TCEP Project No.: 097-039-15
LPS Bid No.: 8365

ADDENDUM NO. 2

LPS Humann Elementary Renovation
6720 Rockwood Ln.
Lincoln, NE 68516
TCEP No.: 097-039-15
February 5, 2016

FIRST FLOOR HVAC DEMOLITION PLAN - AREA 'D'
 SCALE: 1/8" = 1'-0"

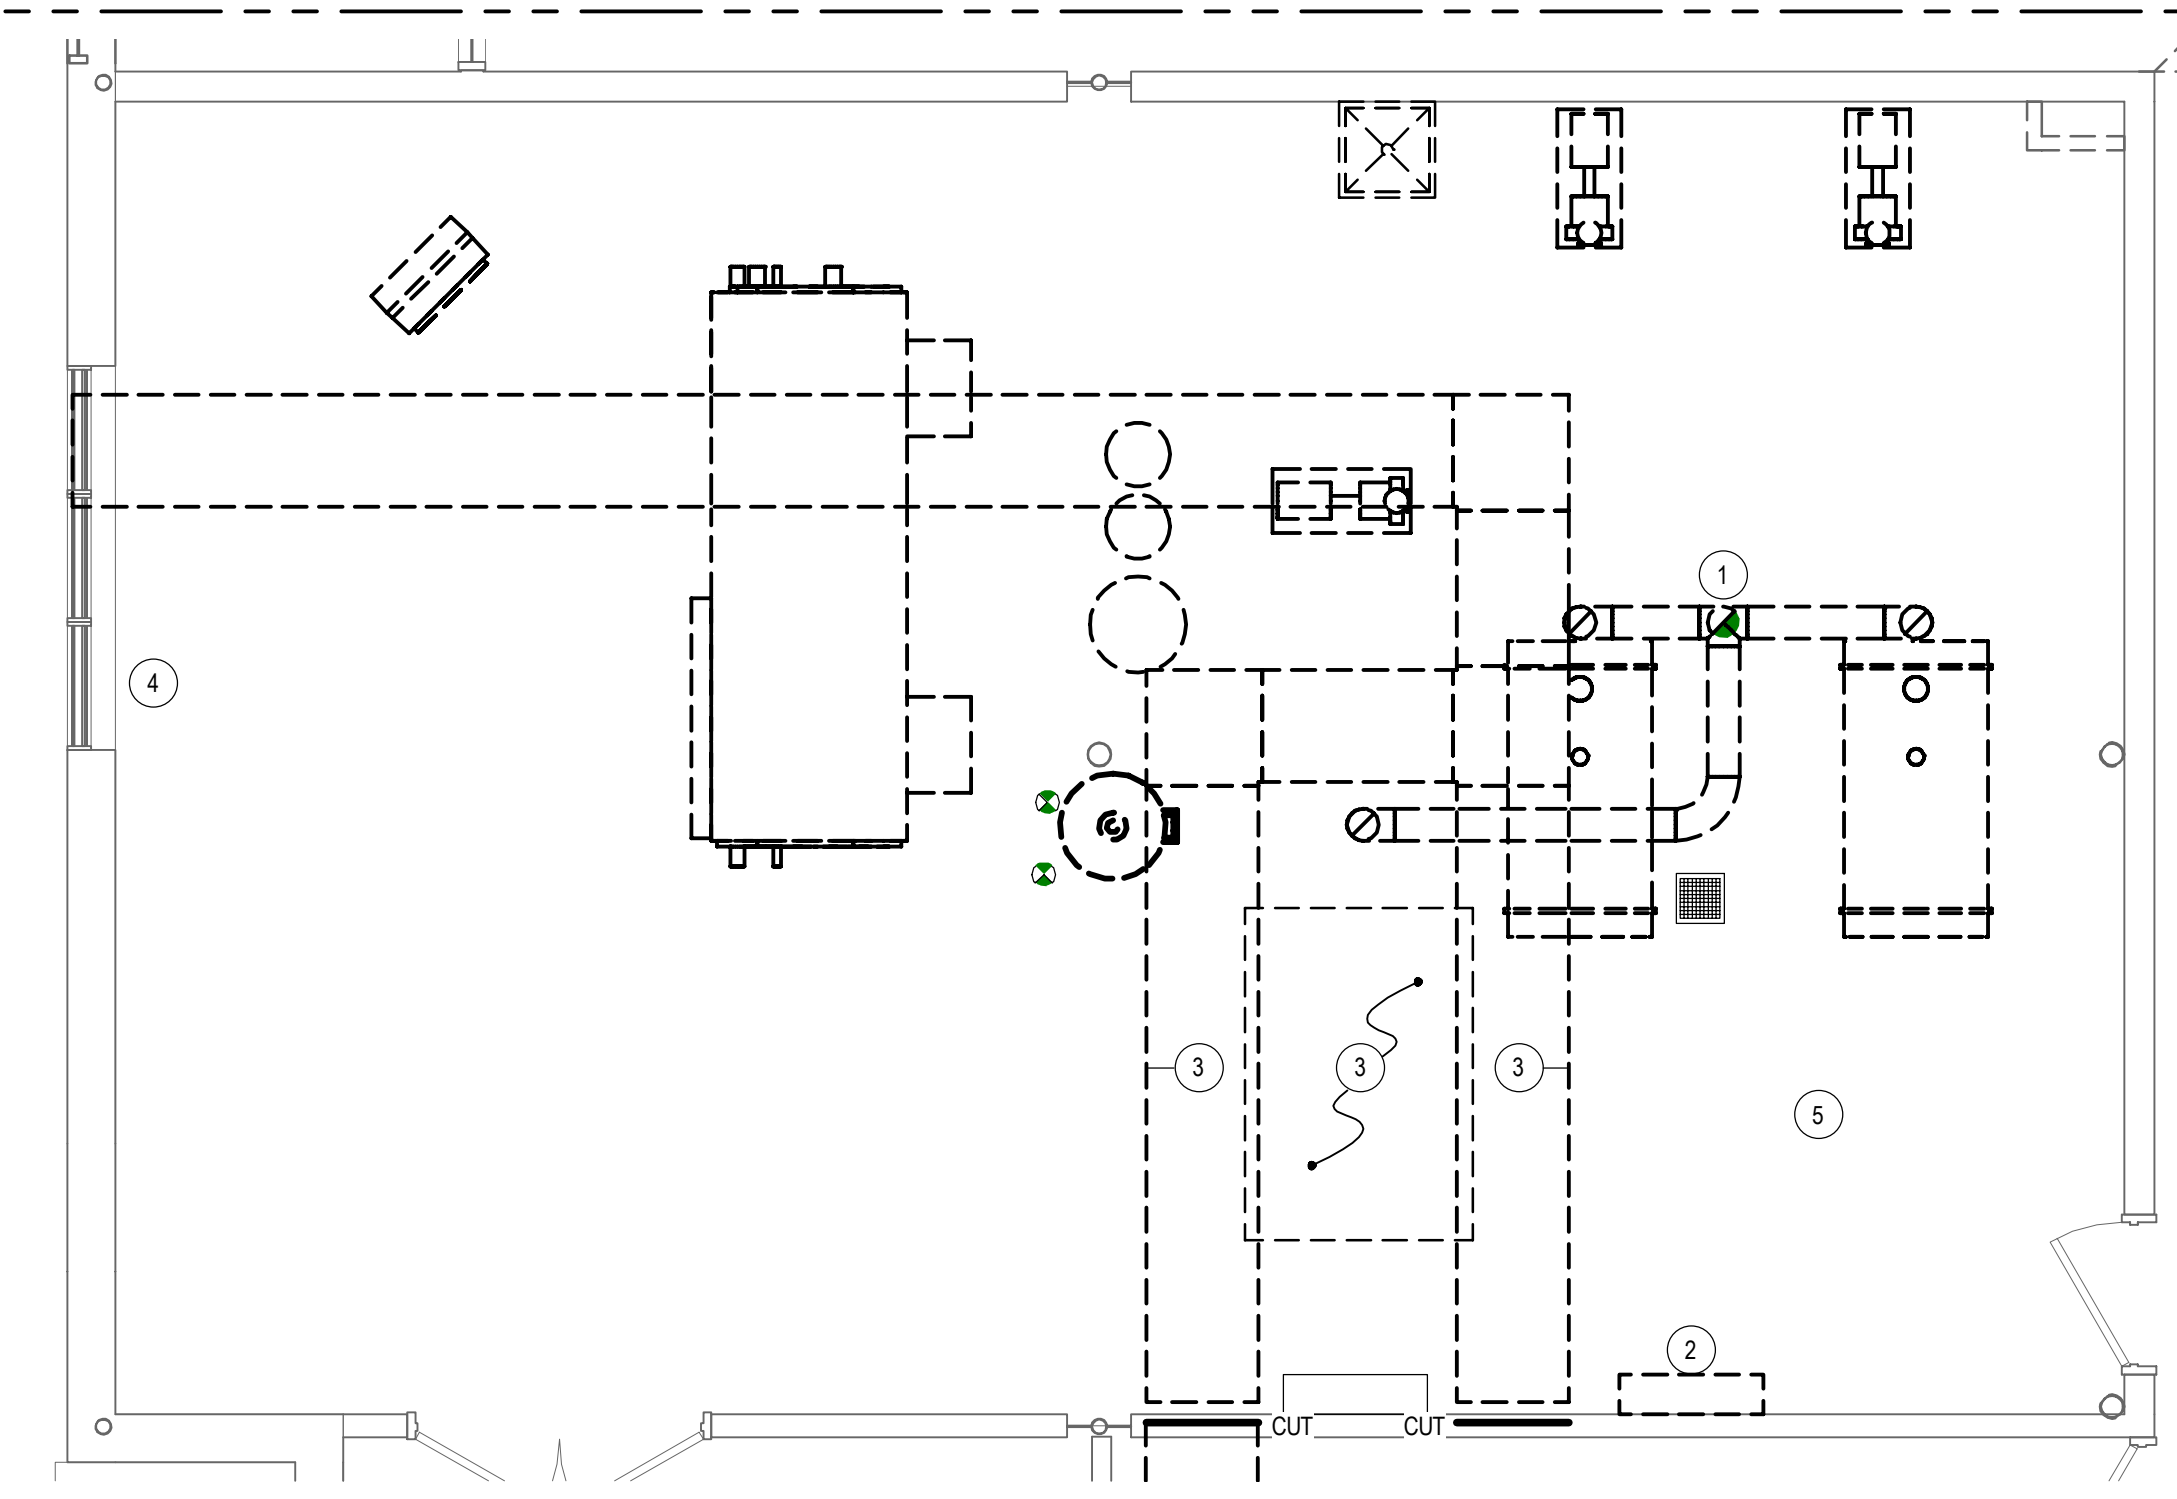
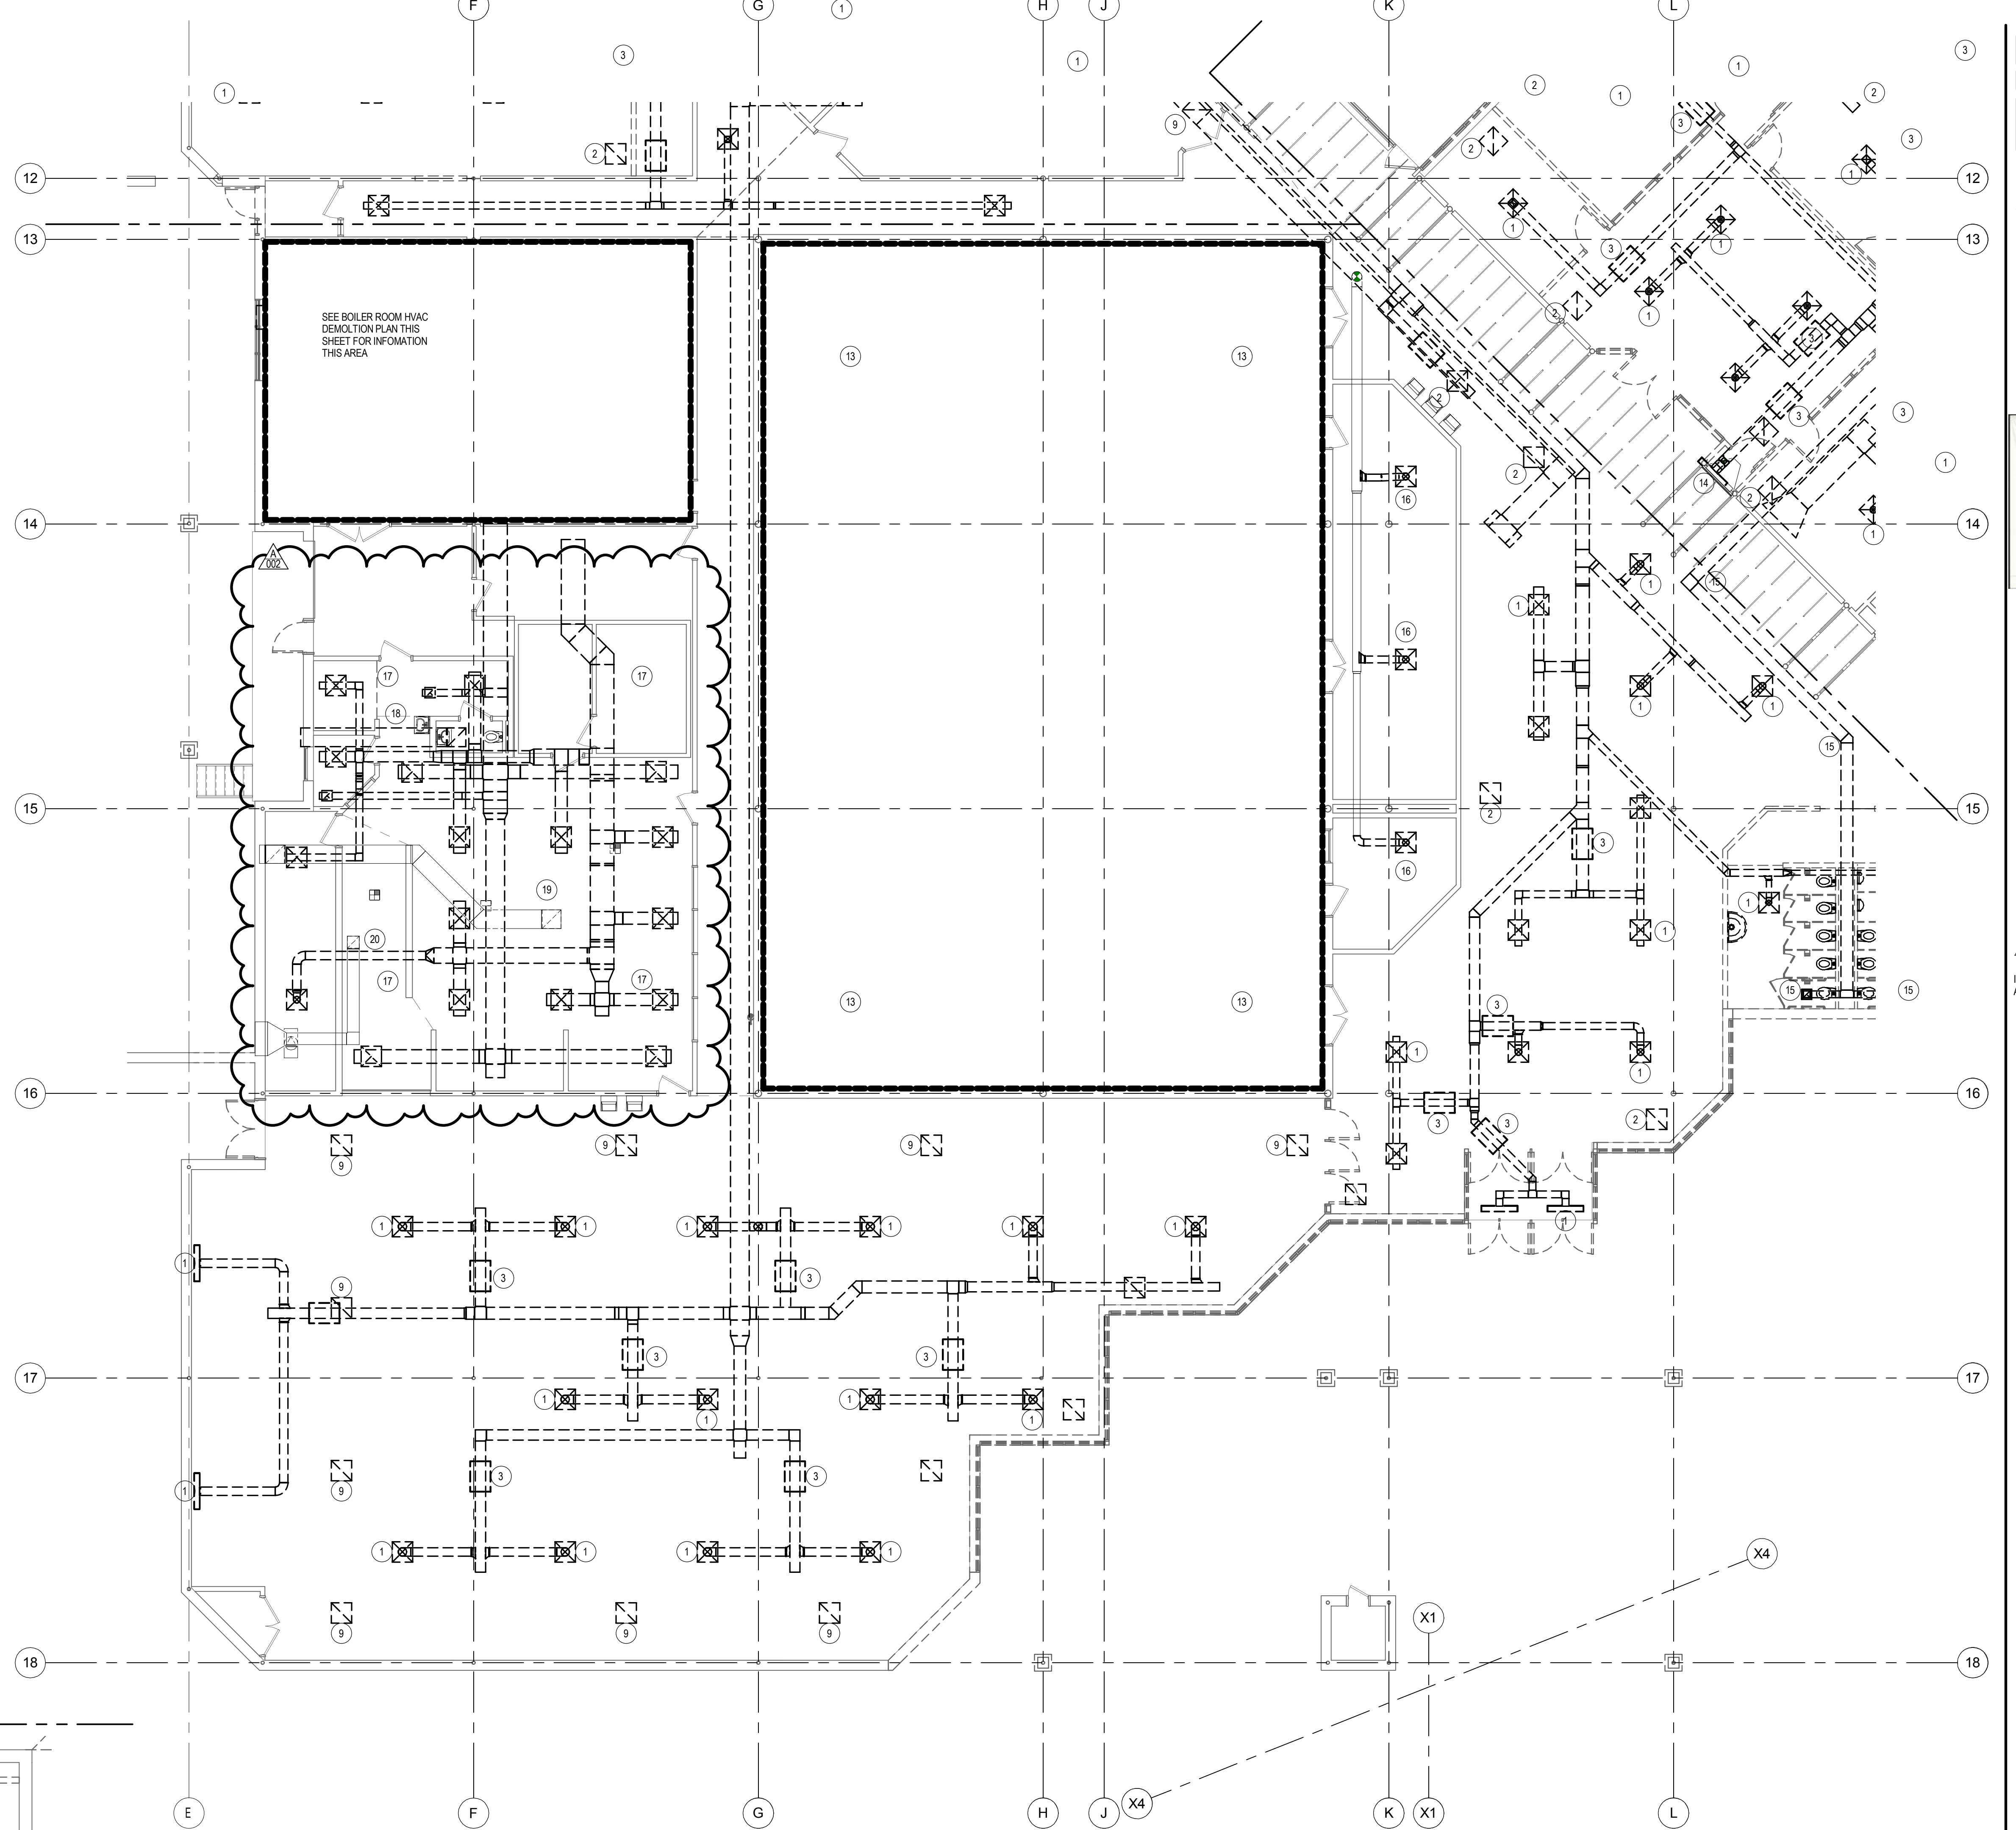
Sheet has been resubmitted to show demolition of supply and return air ductwork in kitchen.

FIRST FLOOR HVAC PLAN - AREA 'D'
SCALE: 1/8" = 1'-0"

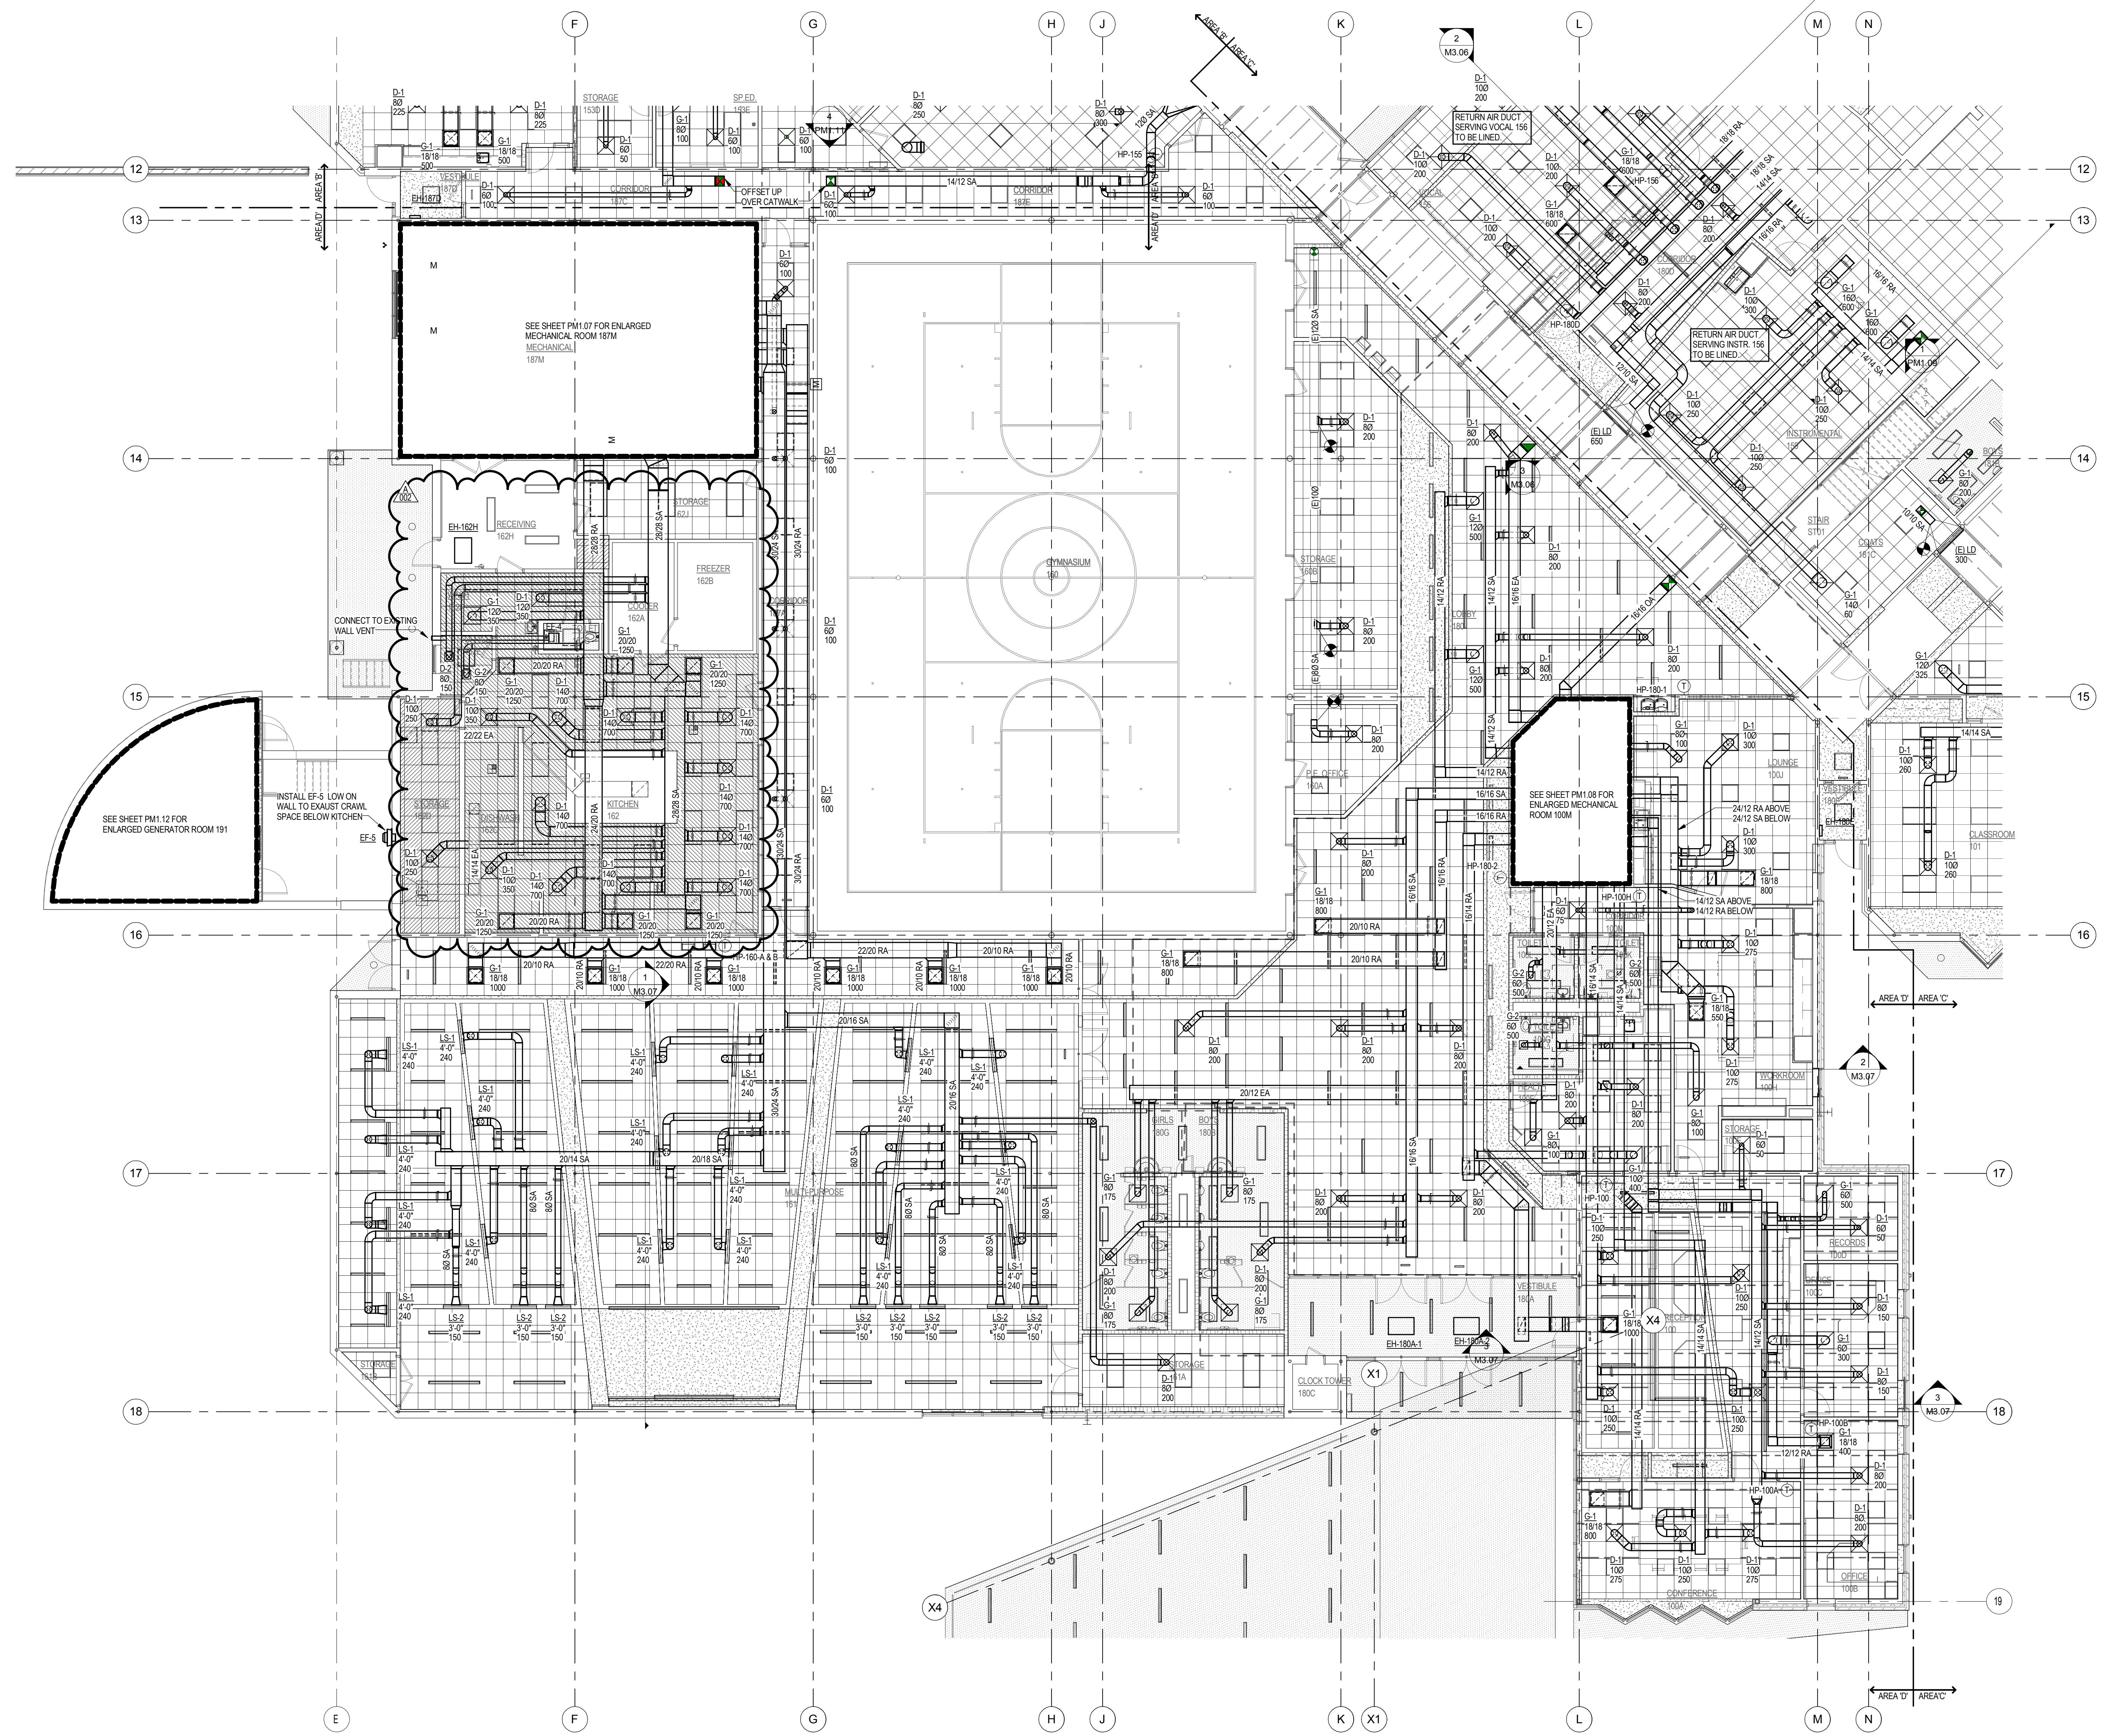
Sheet has been resubmitted to show new duct, diffuser and grille layout in kitchen.
